Access Compliance Report

Public Rights-of-Way

Intersection ID: 7830	Main Street: ABELWOOD_RD	Cross Street: ENGLISH_DR	Location: NE
ADA ID: 40018CEBA621	Ramp Type: Perp	Initial Pass/Fail: Fail	Overall Compliance: No
Severity Score: 8.75			
Codes/Mitigation Info/Possible Solution		Field Measurements/Component Compliance

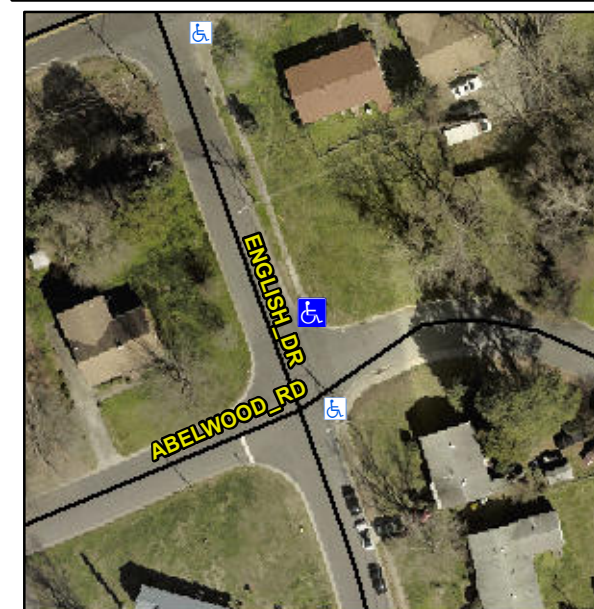
Not Found, R304.5.1

Compliance	Description	Data	Compliance	Description	Data
N/A	Ramp Length (in)	30.0	Yes	Ramp Slope (%)	7.7
No	Ramp Width (in)	38.0	Yes	Ramp XSlope (%)	1.7
N/A	Flare Type LT	N/A	N/A	Flare Type RT	N/A
N/A	Flare Slope LT (%)	N/A	N/A	Flare Slope RT (%)	N/A
N/A	Flare Traversable LT?	N/A	N/A	Flare Traversable RT?	N/A
N/A	Landing Length (in)	N/A	N/A	DWS Provided?	N/A
N/A	Landing Width (in)	N/A	N/A	DWS Contrast?	N/A
N/A	Landing Slope (%)	N/A	N/A	DWS Length (in)	N/A
N/A	Landing X Slope (%)	N/A	N/A	DWS Full Width?	N/A
N/A	Landing Curb? (Y/N)	N/A	N/A	DWS Offset (in)	N/A
N/A	Shared Landing?	N/A			
N/A	Gutter Ponding?	N/A	N/A	Gutter Slope (%)	N/A
N/A	Gutter Lip Ht (in)	N/A	N/A	Gutter X Slope (%)	N/A
N/A	Painted X Walk1?	No	N/A	Painted X Walk2?	N/A
	X Walk 1 Direction	To S		X Walk 2 Direction	N/A
N/A	X Walk 1 Width (in)	N/A	N/A	X Walk 2 Width (in)	N/A
	X Walk 1 Slope (%)	11.9		X Walk 2 Slope (%)	N/A
	X Walk 1 X Slope (%)	2.9		X Walk 2 X Slope (%)	N/A

Remove & Replace Entire Ramp.
